PRE-APPLICATION MEETING

Date: 09/07/2020
Our ref: 2020/1701/PRE
Contact: Jennifer Walsh
Direct line: 020 7974 3500
Email: Jennifer.walsh@camden.gov.uk

Re: Car Park, Clarkson Row, London

DESIGN DEVELOPMENT: MASSING STUDIES

View South Along Clarkson Row

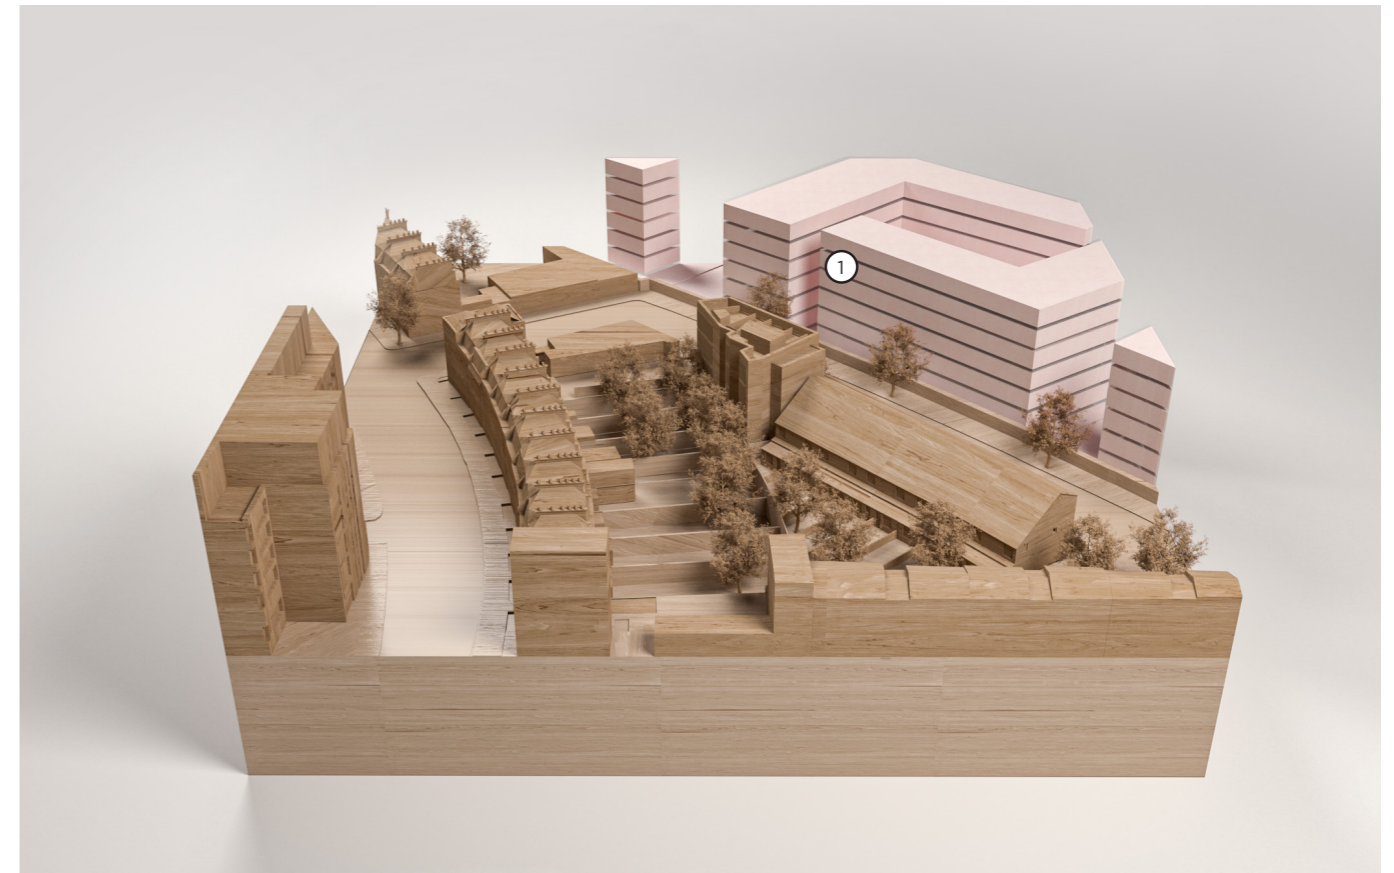
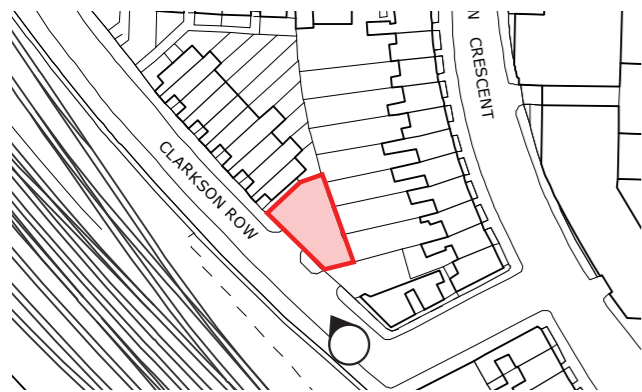
8.8. The original pre-application submission shows a three storey building with attic storey. Whilst the height of the building has a relationship with the neighbouring 1970's terrace and the listed buildings to the rear, the overall bulk of the building is problematic. This is likely caused by the position of the building on the pavement line and the relationship with the terrace. The building sits on the pavement edge with little amenity space at the front. This is at odds with the 1970's terrace which is set some distance away from the pavement. This inconsistency results in the proposed building appearing dominant on the street. In addition, despite the building being broken up into three separate elements, there is a horizontality to the elevations that creates a chunky and heavy aesthetic.

8.10. The revised proposals show a four storey building with a set back attic storey, however issues around the building line and its proximity to the pavement have not been resolved. The submitted drawings do not show that the additional height can be easily accommodated. The building dominates the terrace and the relationship with the listed buildings to the rear is

The current proposal has been set back from the pavement by 1.5 metres and the setback floor has been omitted.

View North Along Clarkson Row

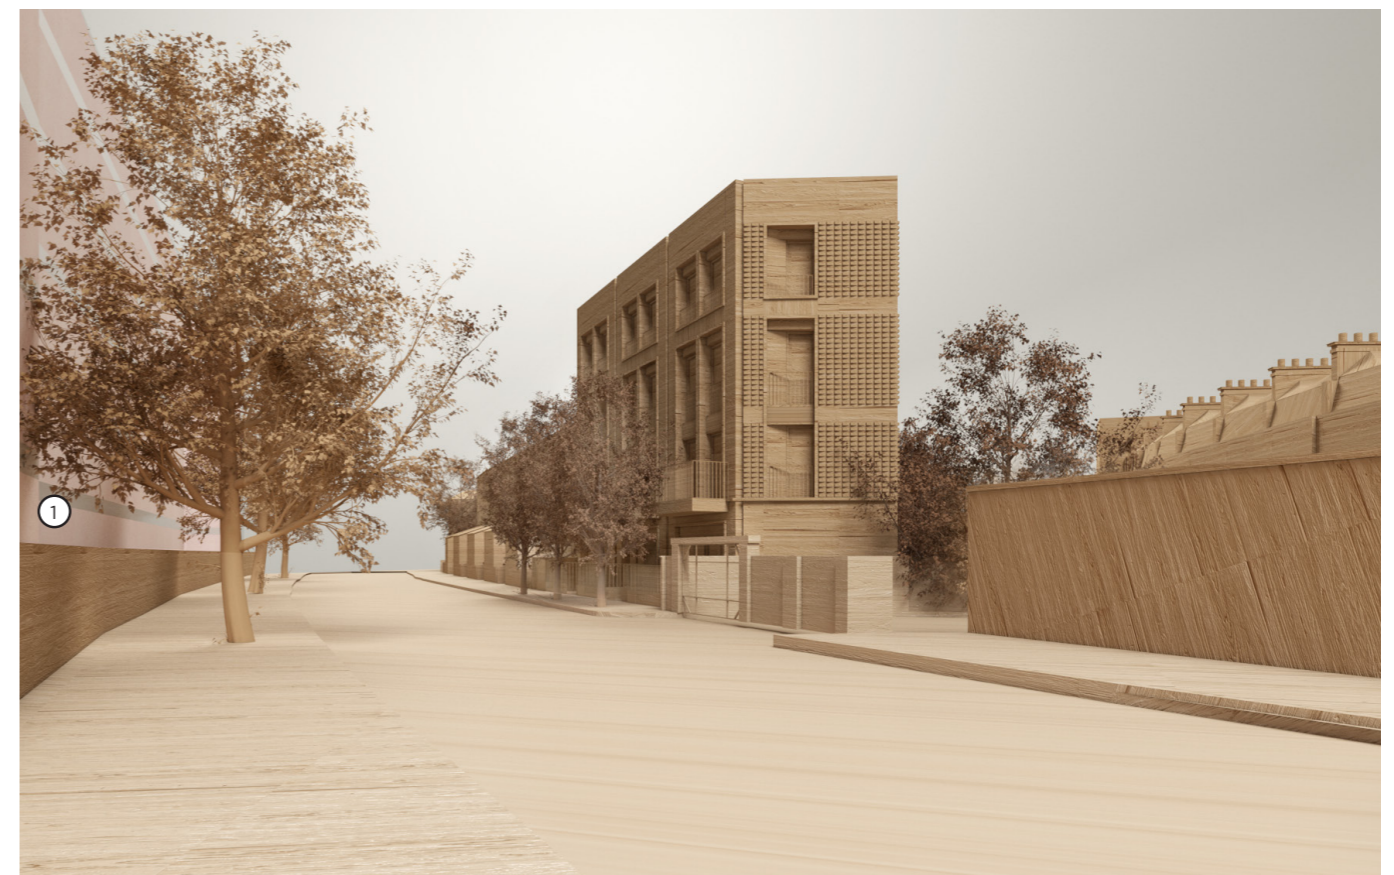
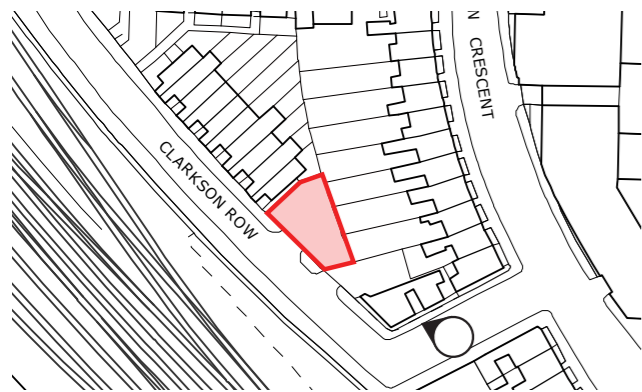
8.12. In the addendum material submitted, a large window and balcony is proposed to the gable elevation fronting the driveway of 1A Clarkson Row. The extensive balcony along the party line is inappropriate and not in keeping with a gable elevation. The previous treatment to this elevation is preferred.

The building has been set back from the front and the rear resulting in a much reduced massing. The balcony facing over 1A Clarkson Row has been repealed by an angled window facing south.

View West

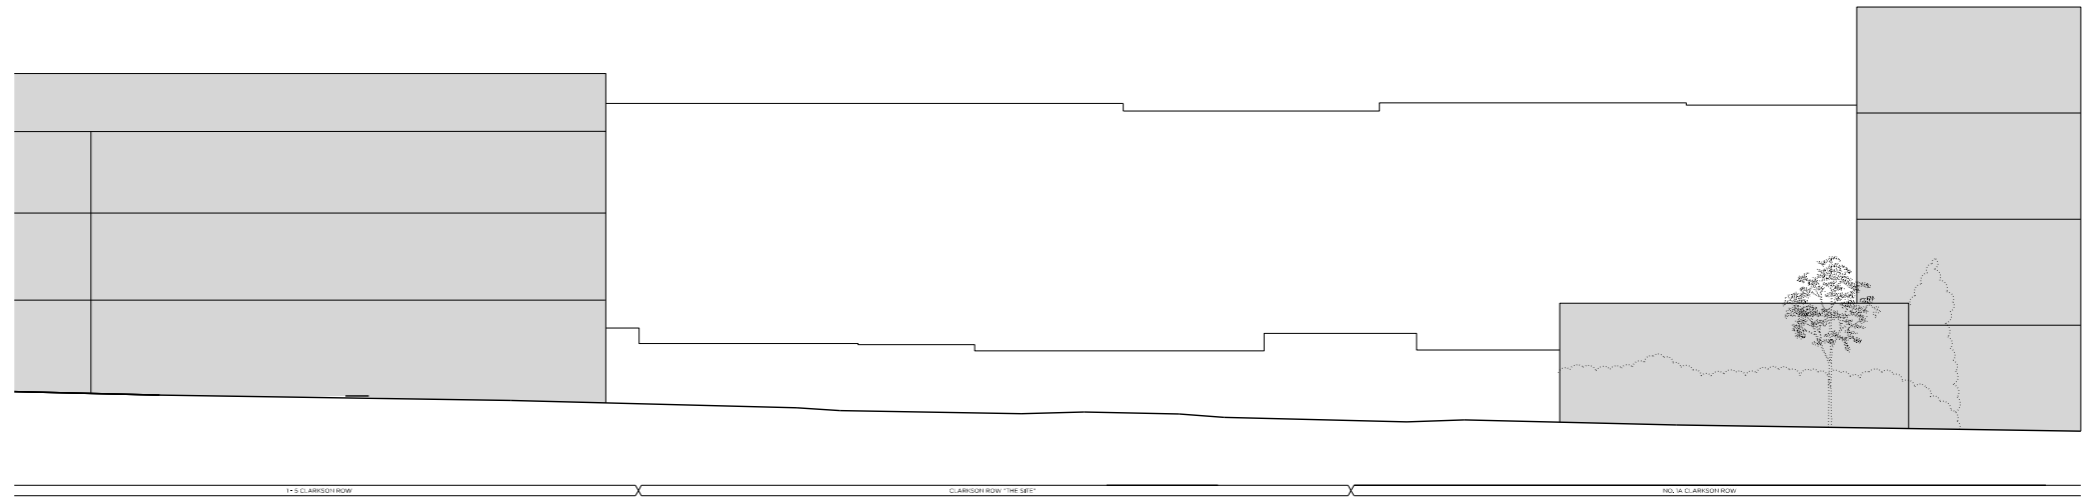
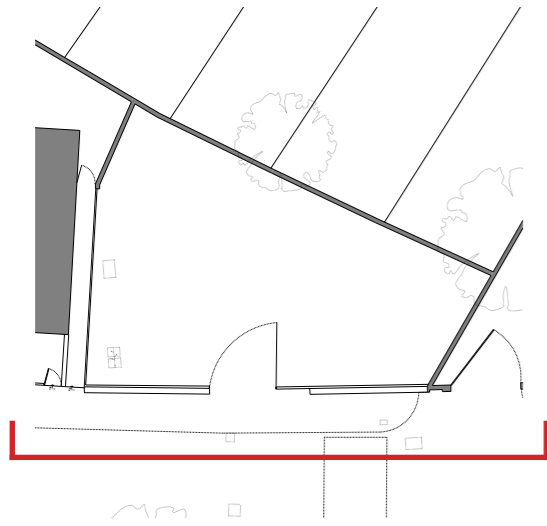
8.14. To the rear of the proposed development, the saw tooth plan form is a positive change and mitigates the overlooking to Mornington Crescent. However, the rear elevation is pushing the envelope and concern is raised to the integration of the building into the rear walls of the listed terrace. The rear building line should be pulled back to allow some breathing space between the wall and the proposed rear elevation. Further justification of how the roof of the building works is required. It seems to sit over the whole footprint removing the saw tooth element. This would also reduce the daylight into these rear windows.

The setback floor has been removed reducing the massing by one floor, the "saw tooth" design is consistent all the way up the façade. The building has been set away from the rear boundary shared with the listed terrace reducing the massing further.
